DC/25/2114

FORMAL TECHNICAL OBJECTION

Application reference: DC/25/2114

Subject: Fundamental discrepancy in Causeway Flow hydraulic modelling – failure to demonstrate the proposed drainage strategy is feasible.

FLOOD RISK ASSESSMENT AND OUTLINE DRAINAGE STRATEGY REVISION 3
Appendix D - Proposed Drainage Plan

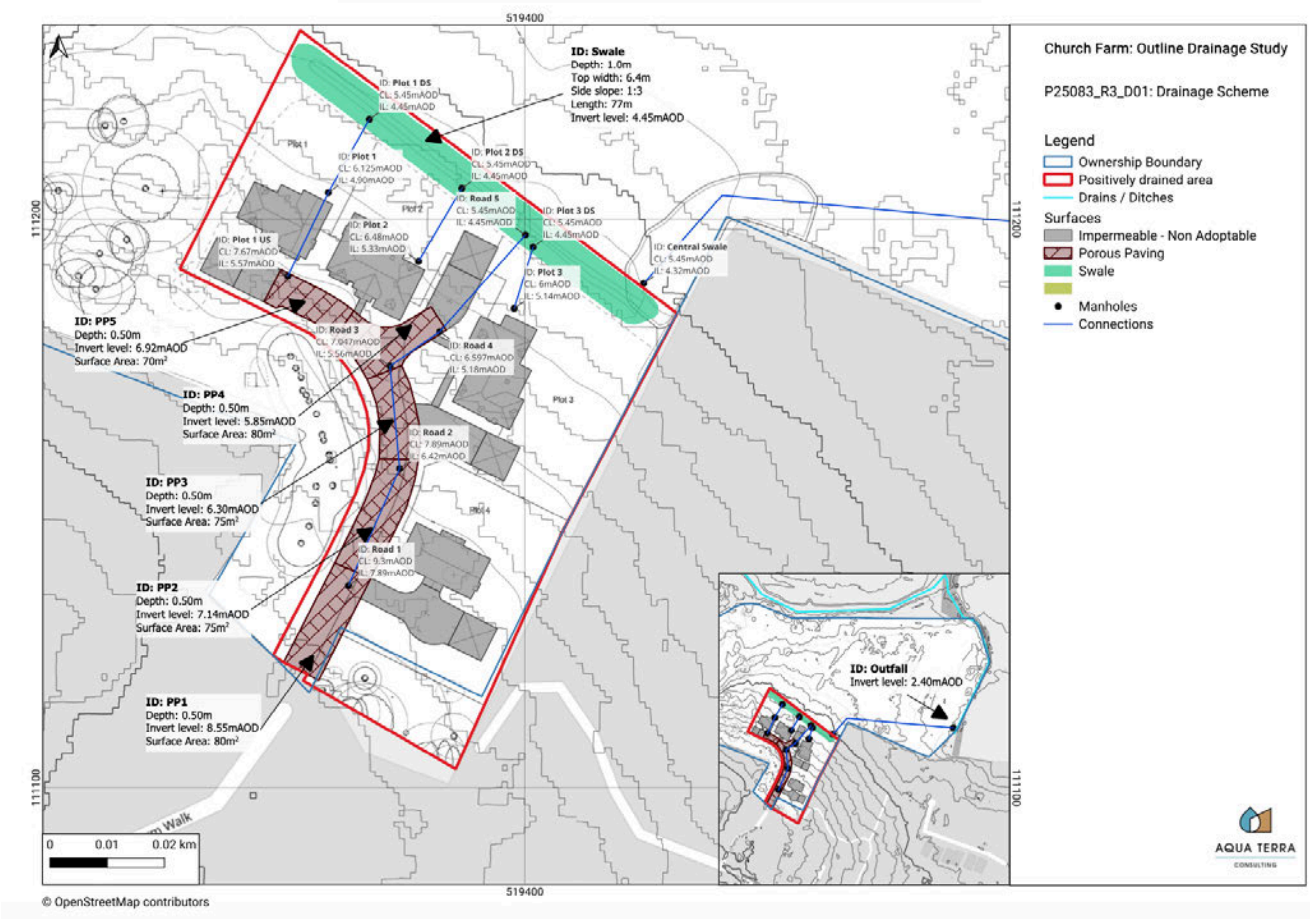
The applicant's documentation states:
"The drain runs along the eastern boundary of the land ownership and is 140m away from the Site boundary."
Source: Flood Risk Assessment and Outline Drainage Strategy Revision 3.

Swale to Outfall - Distance 140m:

The applicant has therefore submitted a hydraulic model using a pipe length substantially shorter than the drainage route identified in its own Revision 3 documentation.

A hydraulic model using a 62.173-metre pipe cannot be relied upon to demonstrate the feasibility of a proposed drainage connection identified as approximately 140 metres without evidence establishing that the two configurations are equivalent.

140m ROUTE – 1.000m OUTFALL

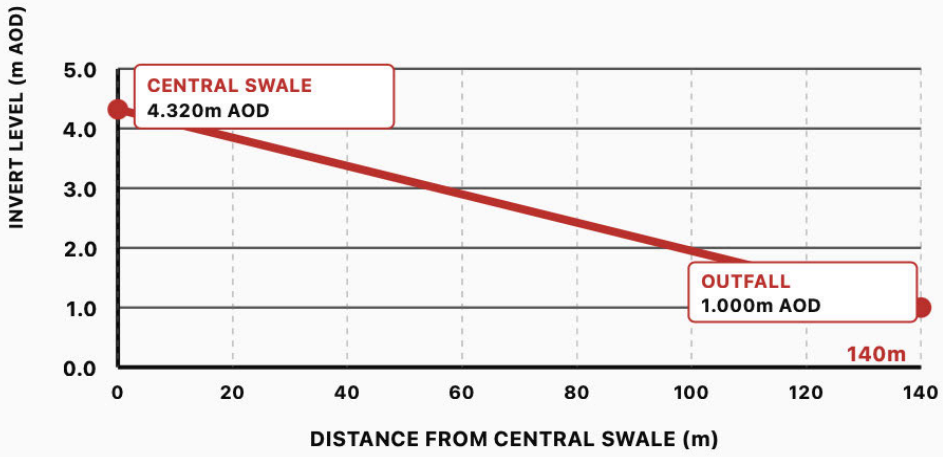
Gradient 1:42.2 (2.37%)

Central Swale: 4.320m AOD → Outfall: 1.000m AOD

Vertical fall: 3.320m

140m ROUTE – 2.400m OUTFALL

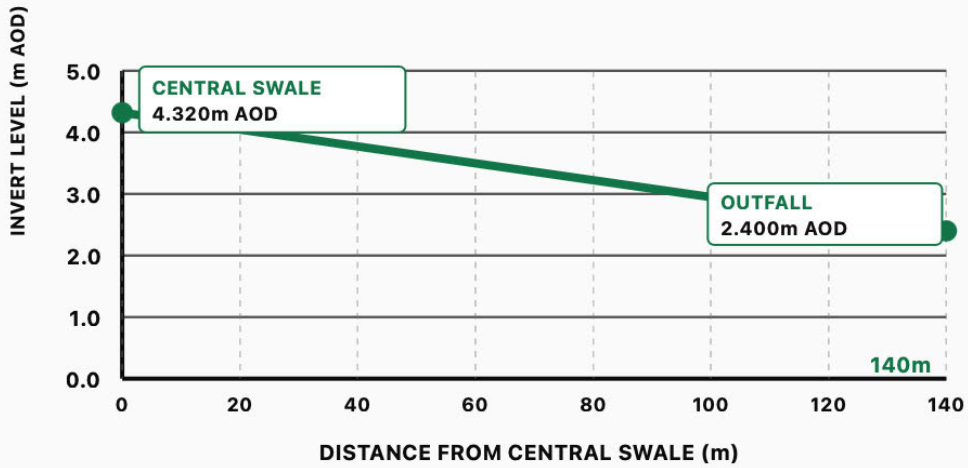
Gradient 1:72.9 (1.37%)

Central Swale: 4.320m AOD → Outfall: 2.400m AOD

Vertical fall: 1.920m

- 2.400m AOD identified in Appendix D.
- 1.000m AOD used as the downstream invert in the Causeway model.

The Council must also establish what the 2.400m AOD level actually represents and how it relates to the proposed outfall.
